Department of Energy

Enclosure: "Report of the Nuclear Regulatory Commission -
Department of Energy Meeting of the Geohydrology Testing
Program before Construction of the Exploratory Shaft,"
April 9, 1987, with 16 attachments.

Report of the Nuclear Regulatory Commission - Department of Energy
Meeting of the Geohydrology Testing Program before Construction of the
Exploratory Shaft

April 9, 1987

FIGURE 1

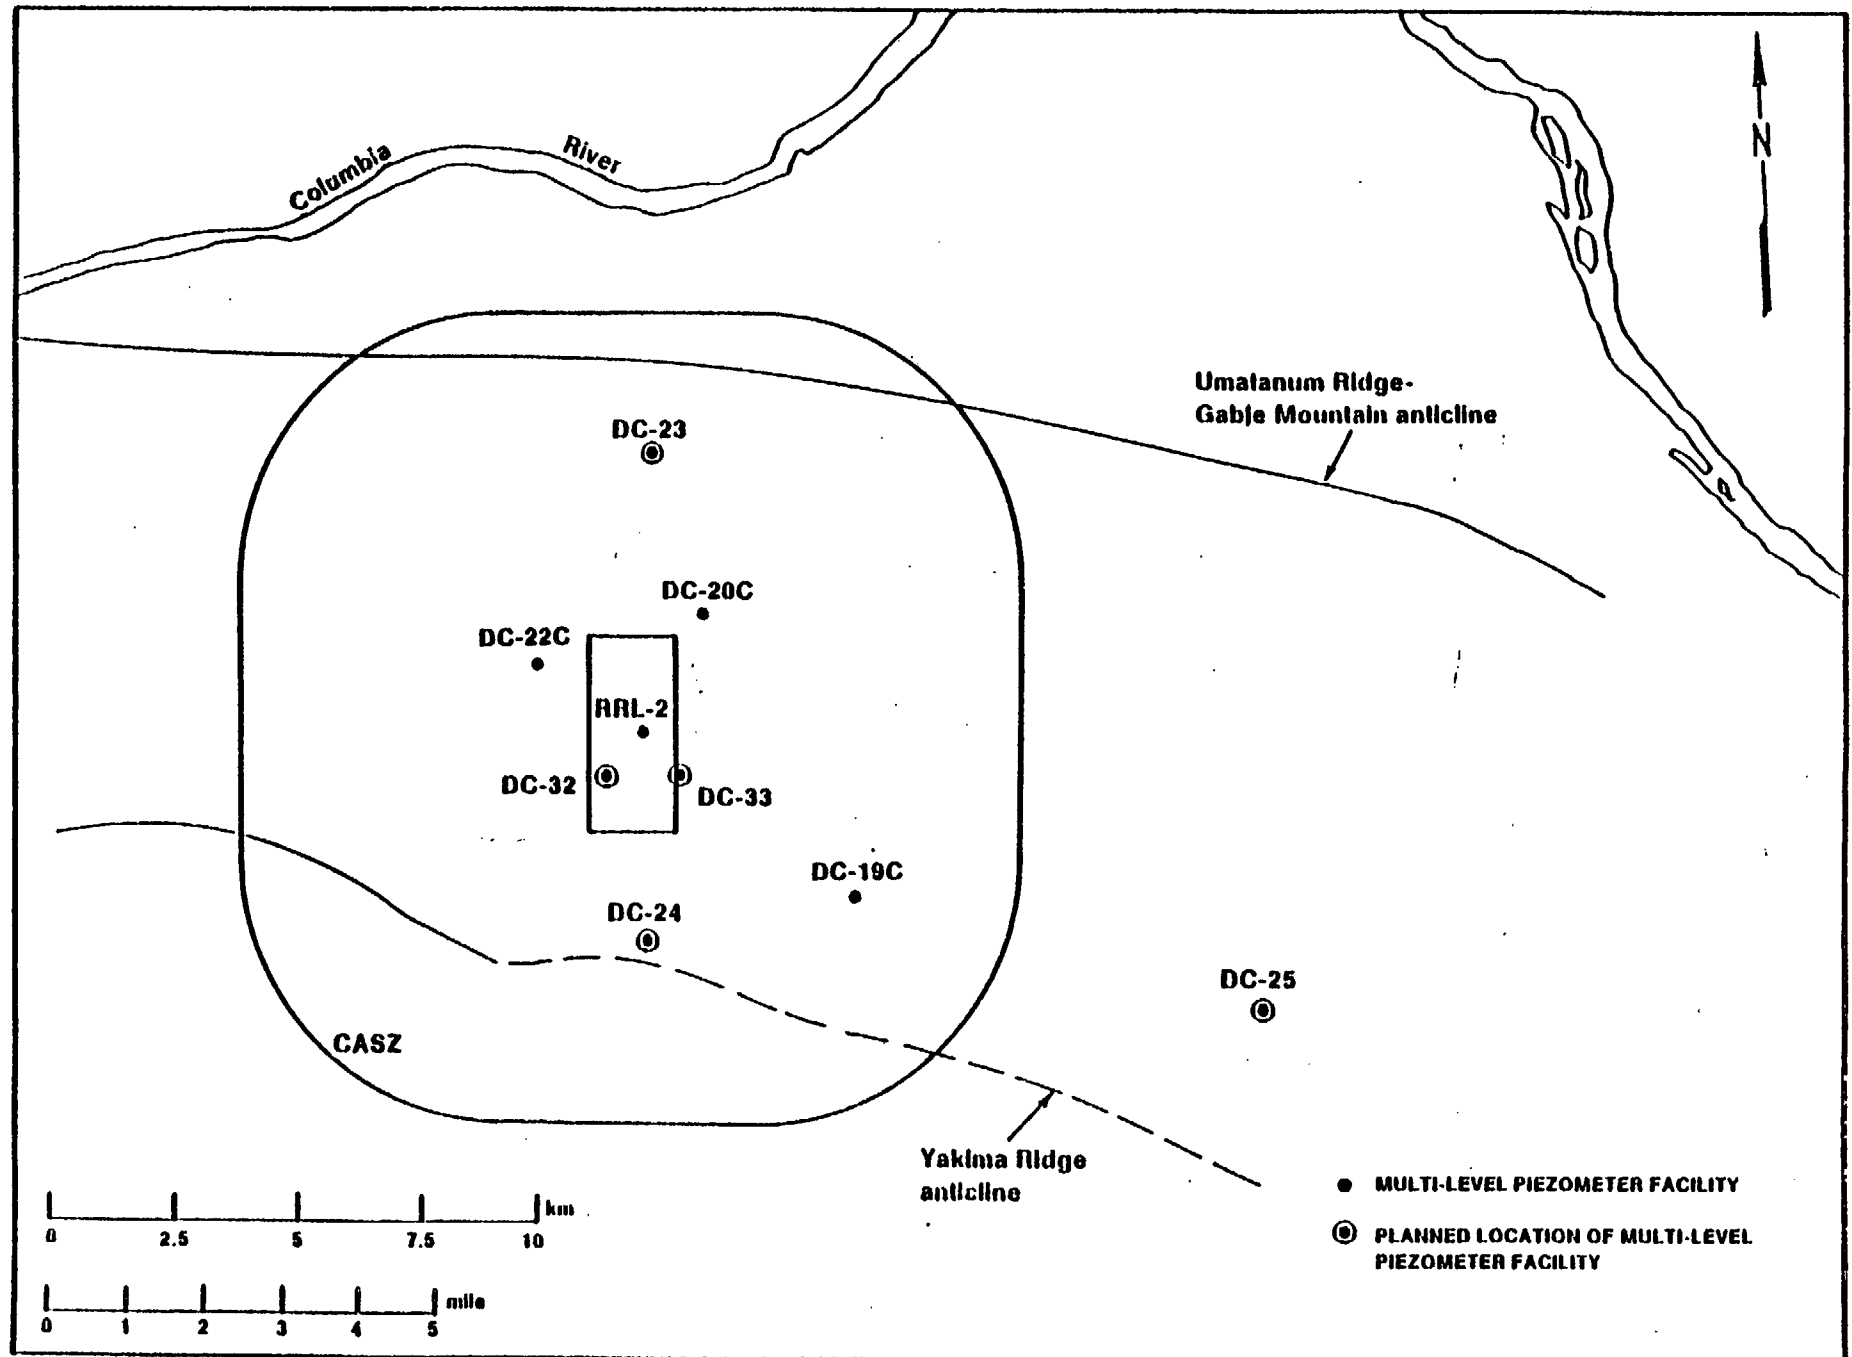
- **BWIP did not Document the Basis for Concluding that Cementing of the Rocky Coulee Flow Top at RRL-2A and RRL-6 During Construction does not Significantly Inhibit Hydraulic Communication**

- **BWIP has Provided the Requested Documentation**
- **Spot Cementing of Rocky Coulee Flow Top at RRL-2A had Minimal Effect on Hydraulic Properties**
 - **Transmissivity Estimates for Hydraulic Test Performed Pre- and Post-Cementing are of Similar Magnitude**
 - **Dynamic Temperature Logs Indicate Water Production from the Rocky Coulee Flow Top**
- **Cementing Effects on Hydraulic Properties of the Rocky Coulee Flow Top at RRL-6 not as Well Known**
 - **Time-Series Water-Level Data from Subsequent Monitoring are Consistent with Data from Other Rocky Coulee Flow Top Observation Points**
 - **Addition of Monitoring at DC-32 Makes Measurements at RRL-6 Less Critical**

Model Domain and Deterministic Inputs For the Pre-Waste-
Emplacement Stochastic Groundwater Travel Time Analysis

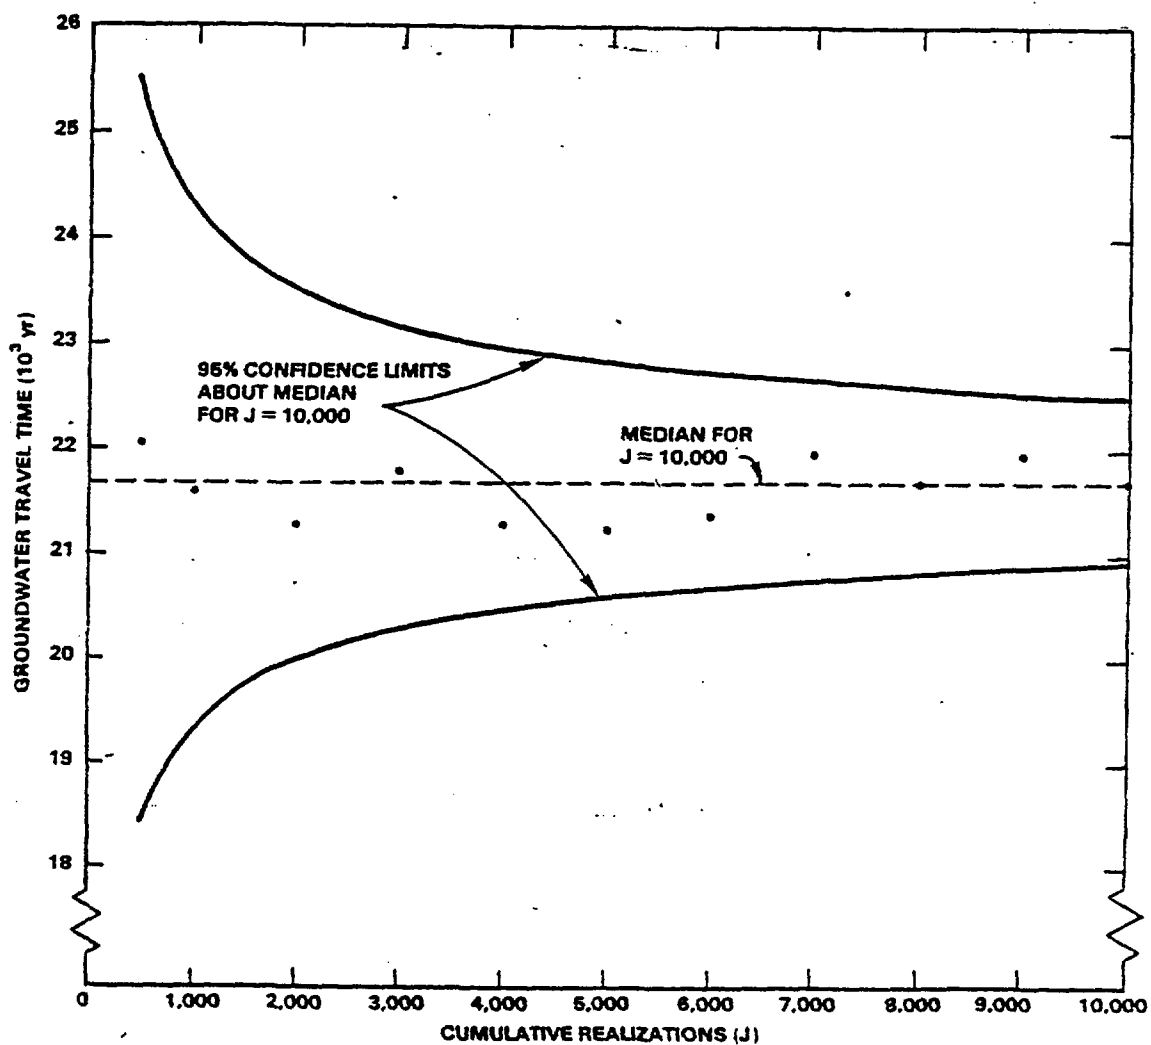
In the Reference Case, the domain under study is a rectangle with dimensions 20 km by 10 km. Impermeable boundary conditions are set along the two longer dimensions. Constant head boundaries are set along the shorter dimensions so that the regional hydraulic head gradient is 10^{-3} . Effective thickness is deterministically set at a uniform value of 0.04 m. Figure 1 shows the flow domain and deterministic input as defined for the Reference

FIGURE 1: LOCATION MAP FOR SELECTED BOREHOLES

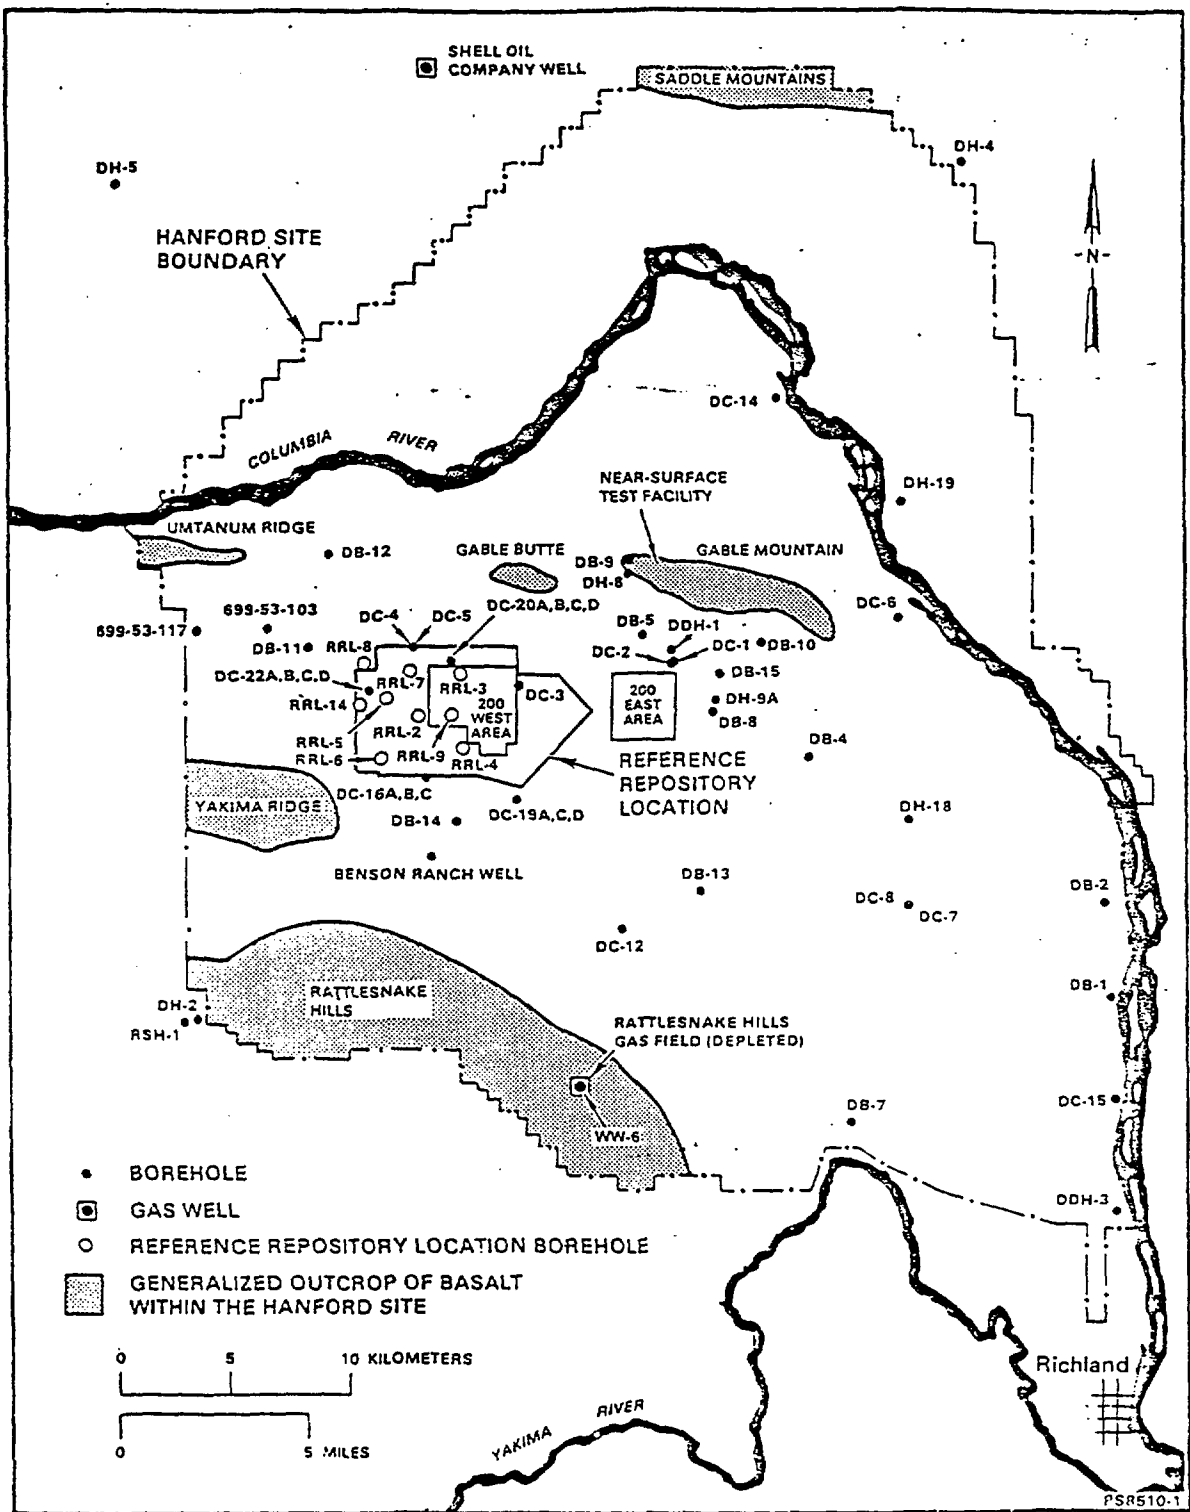
As shown on Figure 1, most of the boreholes screened in the Wanapum Formation are located in the vicinity of the RRL. Only DB-1, DB-2 and DDH-3 are located in the southeastern part of the Hanford Site. The effect of incorporating these three boreholes in the analysis on the estimated hydraulic head has been investigated. Structural models have been identified in two cases: (1) using observations from all eleven boreholes, and (2) not accounting for observations at boreholes DB-1, DB-2, and DDH-3.

FIGURE 2: LOCATION MAP FOR SELECTED BOREHOLES

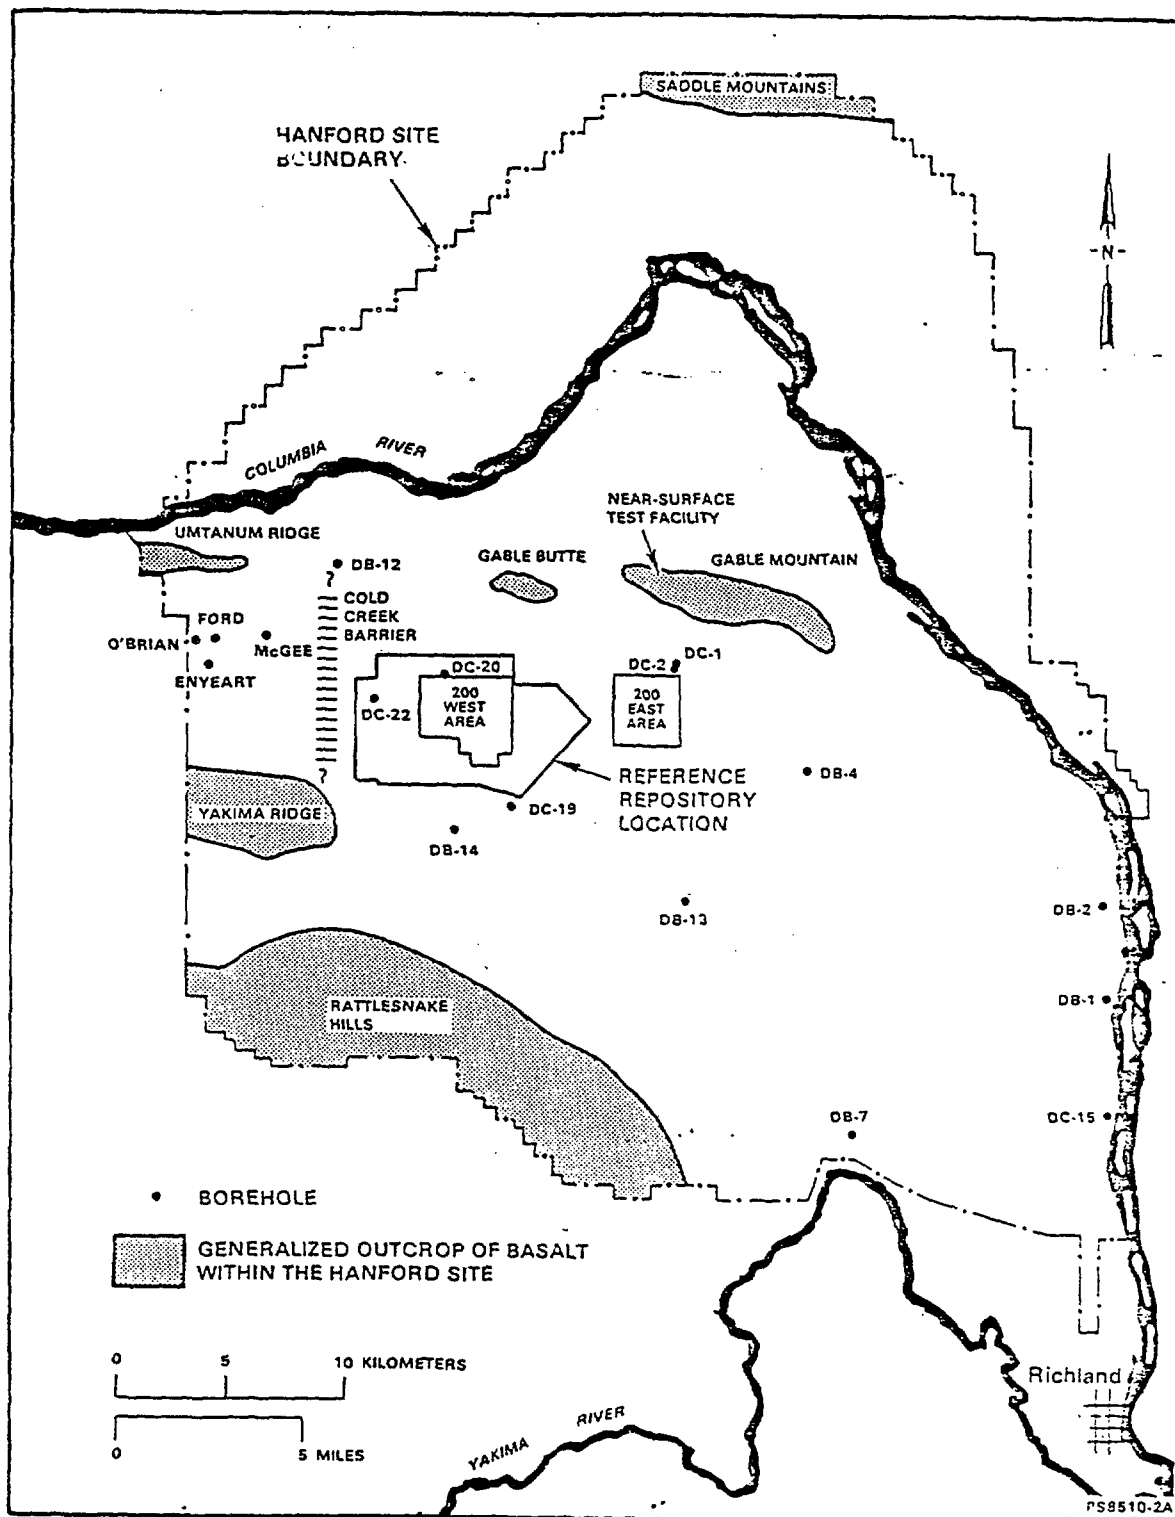
generally higher than the head elevations in the same stratigraphic horizon within the RRL east of the Cold Creek "Barrier" (Figure 2). This anomaly is interpreted by DOE as a no-flow or low-flow lateral boundary (DOE, 1986). However, this interpretation has not yet been substantiated by sufficient evidence. Since the water levels at the Ford and O'Brian wells behave differently than those at the other wells, and since such anomalies cannot be accounted for by a covariance function derived from a limited number of observations, these observations were dropped in the model identification procedure.
